RE: USFWS - Wadulh Lagoon Tidal Wetland Enhancement Project

WADULH LAGOON TIDAL WETLAND ENHANCEMENT PROJECT BRIEFING

Re: Mad River Slough Restoration Project and CCP Revision

RE: USFWS - Mad River Slough Restoration -Wadulh Lagoon – Comment Letter #2

4

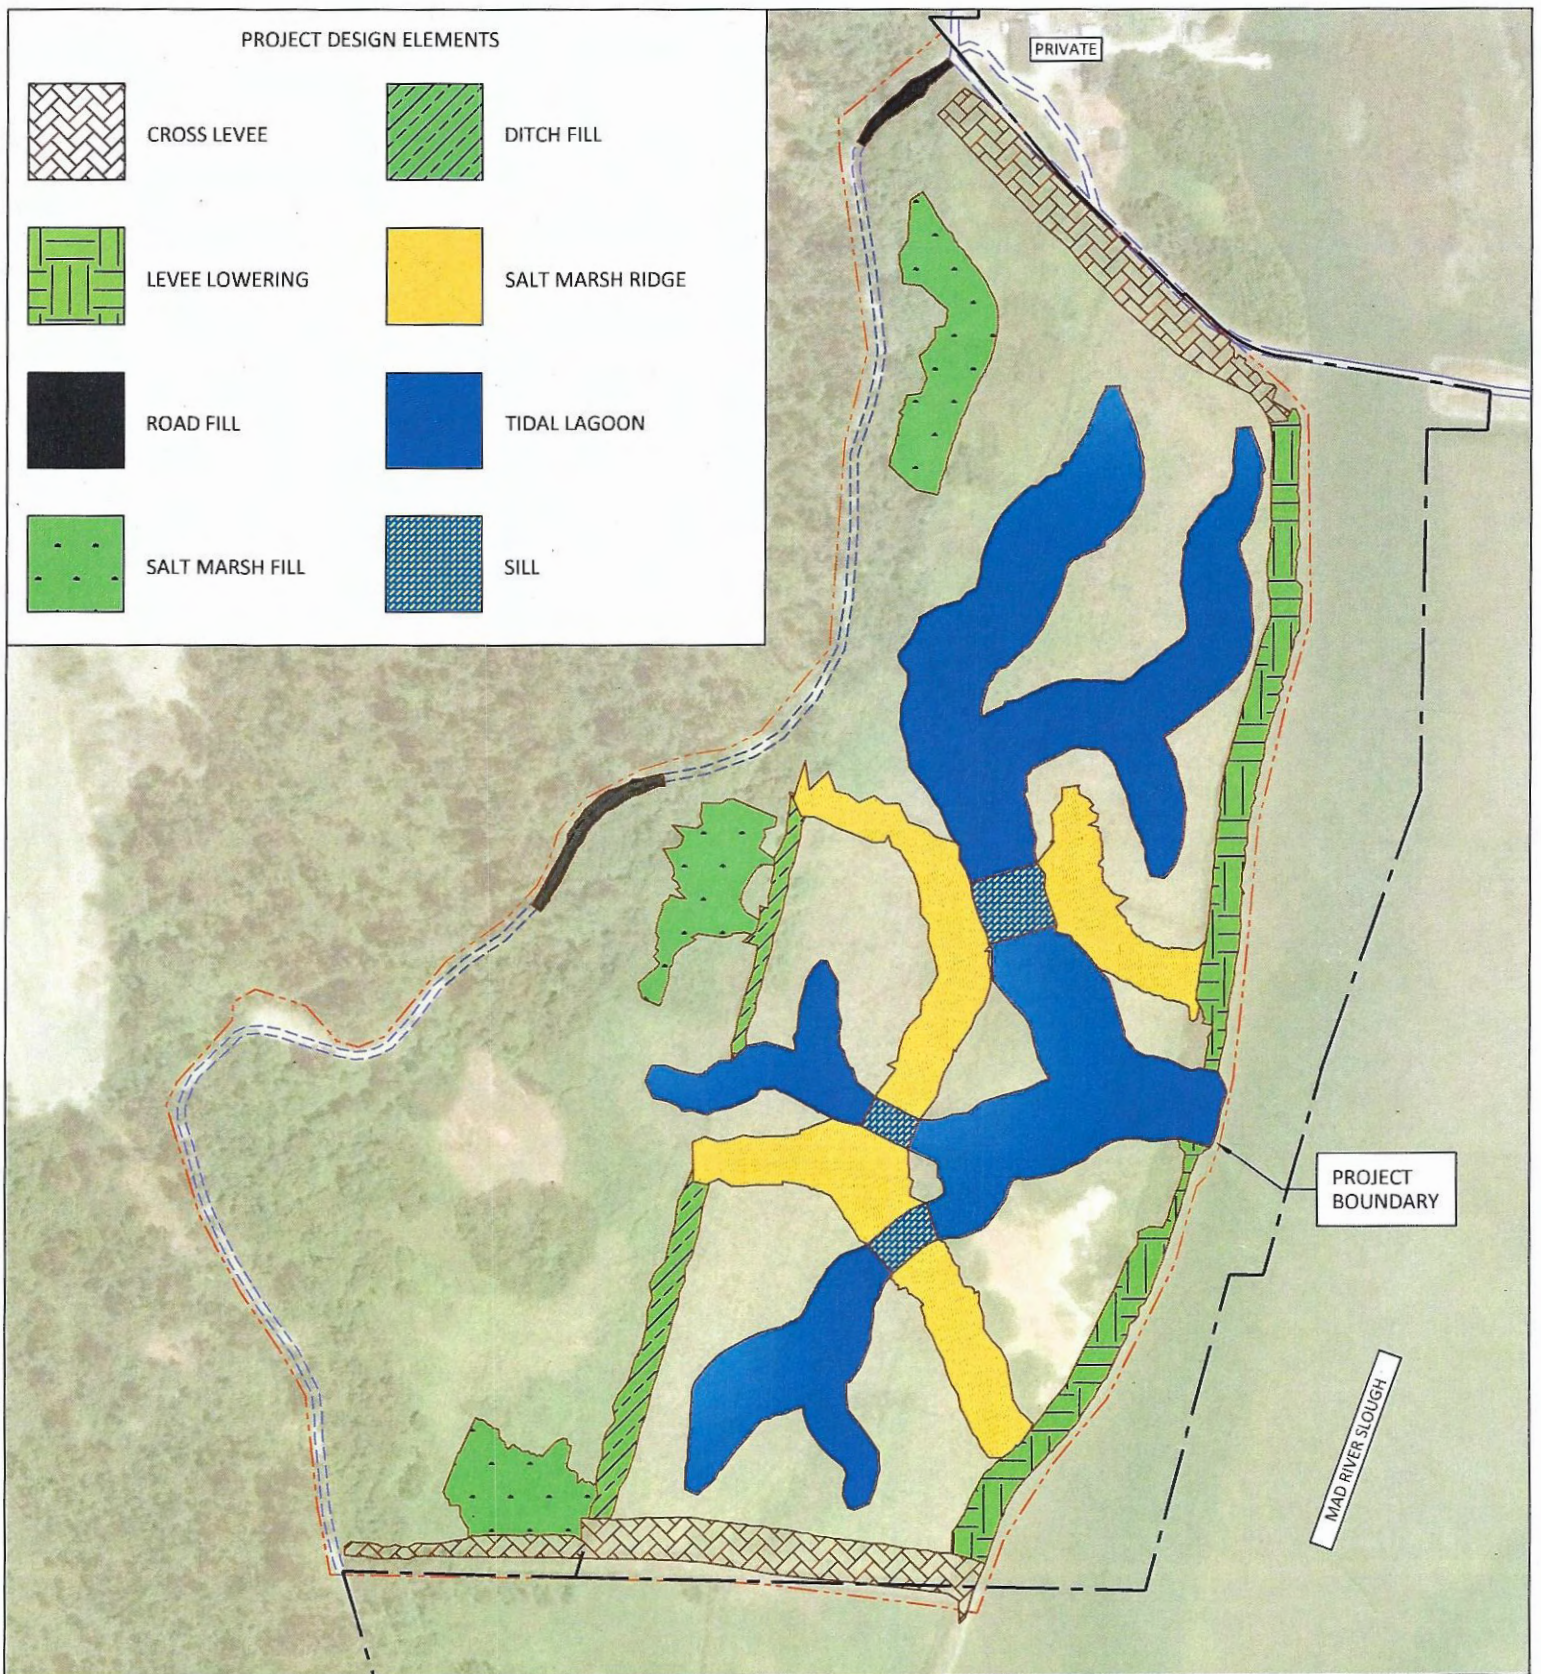
On behalf of the of the owners, residents, and shellfish producers at Sea Horse Ranch LLC, located at 6210 Lanphere Road, Arcata, CA (APN 506-291-013), and the Ferreira & Son Dairy, we respectfully submit this letter to the U.S. Fish and Wildlife Service (USFWS) and the Humboldt Bay National Wildlife Refuge (HBNWR) with regard to the proposed Wadulh Lagoon Tidal Wetland Enhancement Project proposed for portions of APN 506-291-014 along Mad River Slough just south of the Lanphere Road bridge (see attached map).
